Carencro City Hall Expansion 2026
City of Carencro

Carencro City Hall Expansion

- d. The contract documents were submitted to third party review and inspection agency for the City of Carencro, Building Code Inspection Services LLC (Cooney Richard), for review. Comments were received on February 26, 2026. Those comments are hereby made part of the contract documents. The contractor shall comply with ALL requirements in the Commercial Construction Plan Review report dated February 26, 2026. See Attachment No. Two (2).

- e. The contract documents were submitted for review to the City of Carencro, who in turn engaged the City Engineer, C. H. Fenstermaker & Associates, LLC. A review letter dated March 13, 2026, was received on March 18, 2026. Those comments are hereby made part of the contract documents. The contractor shall comply with ALL requirements in the Fenstermaker Plan Review letter dated March 13, 2026. See Attachment No. Three (3).

HANDICAP PARKING STALL
N.T.S.

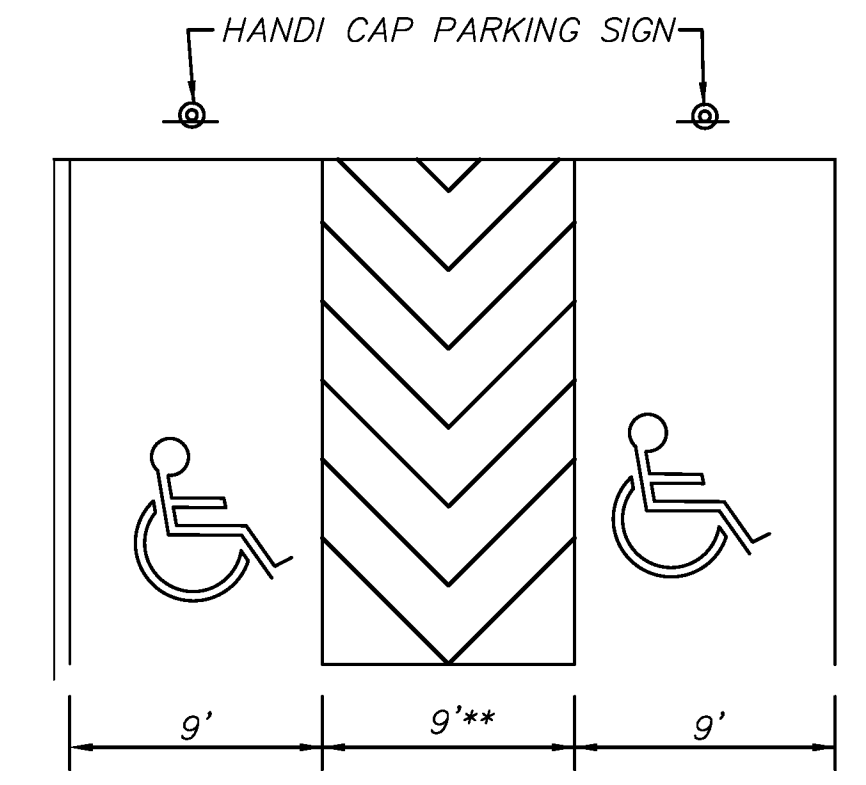
- c. Sheet G.003 –
 - i. The dimensions shown in drawing F.11 are different than the ones used on sheet C.13R. The ones on C.13R are to be used.
- d. Sheets C.1 through C.18 –

- e. Dimensions of Handicap Parking Stall Detail do not match H.C. Parking Detail F.11 on Sht. G.003. Revise accordingly for Civil and Arch to match.
9. Plan Sht. G.000 – Title Sheet & Architectural Site Plan

TYPICAL HANDICAP RAMP DETAIL TO PARKING LOT AND/OR ROADWAY
N.T.S.

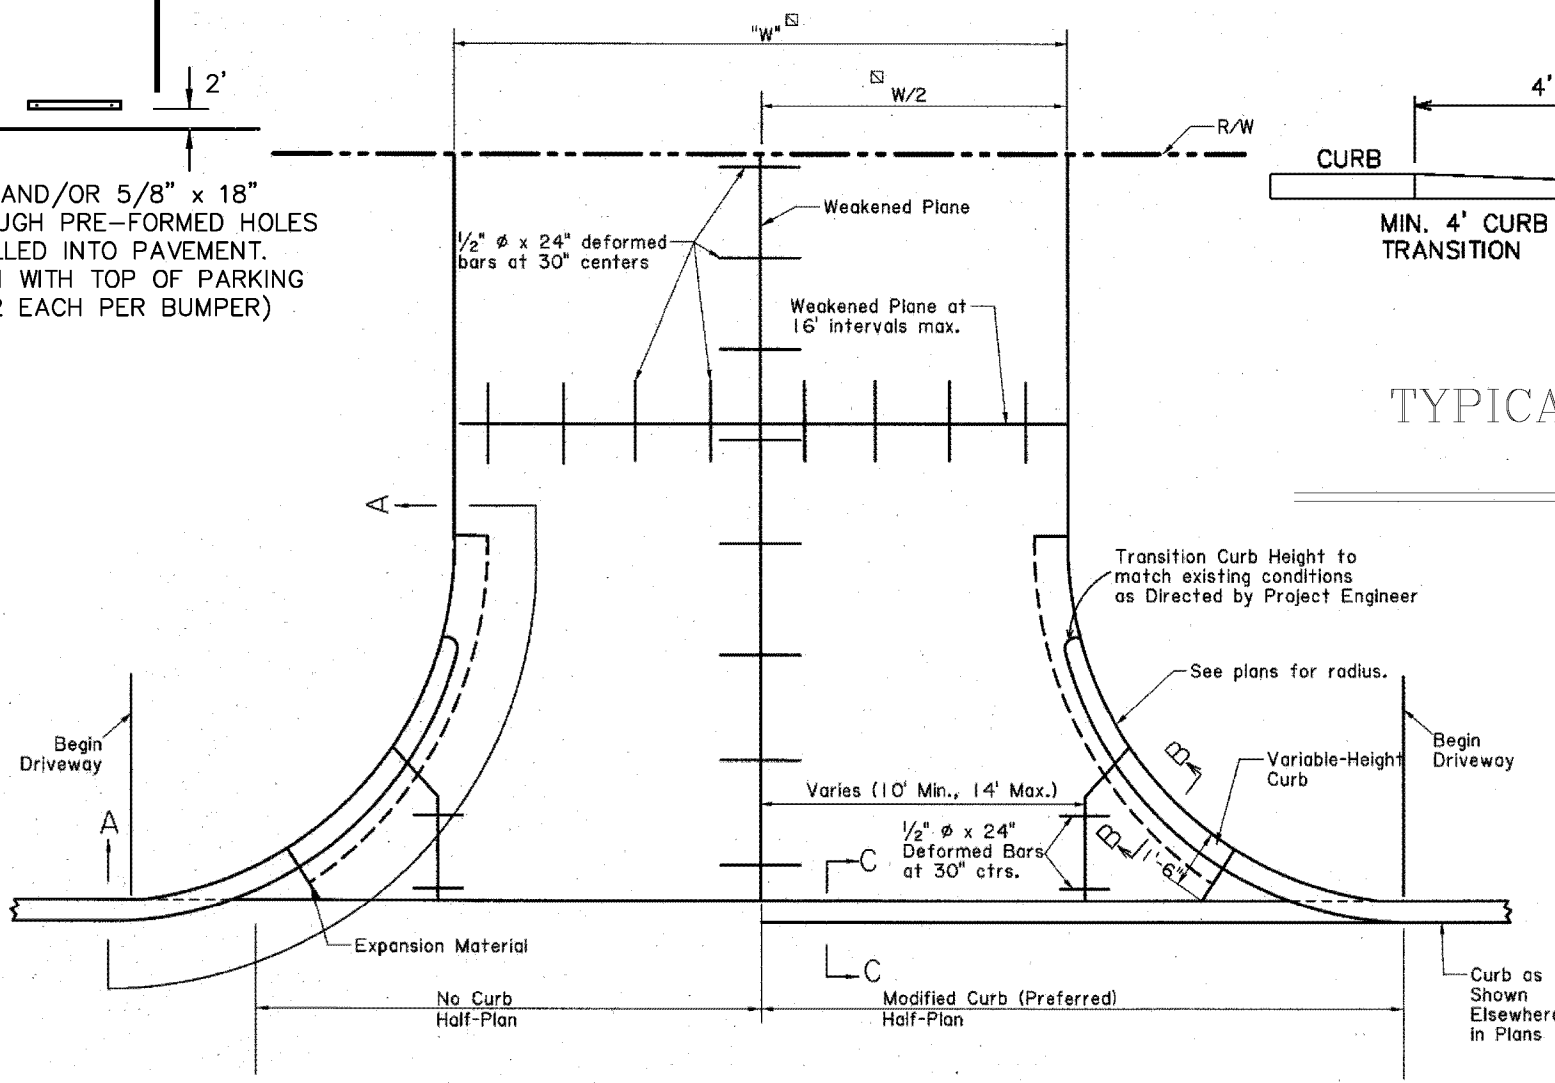
- c. Revise Section Thru Concrete Walk Detail to read “Slope to Road” instead of “Slope to Parking Lot”.
 - d. Revise Typical Handicap Ramp Detail at Driveway to show uniform location and dimensions of 1:12 slope in the ramp portion of the sidewalk.
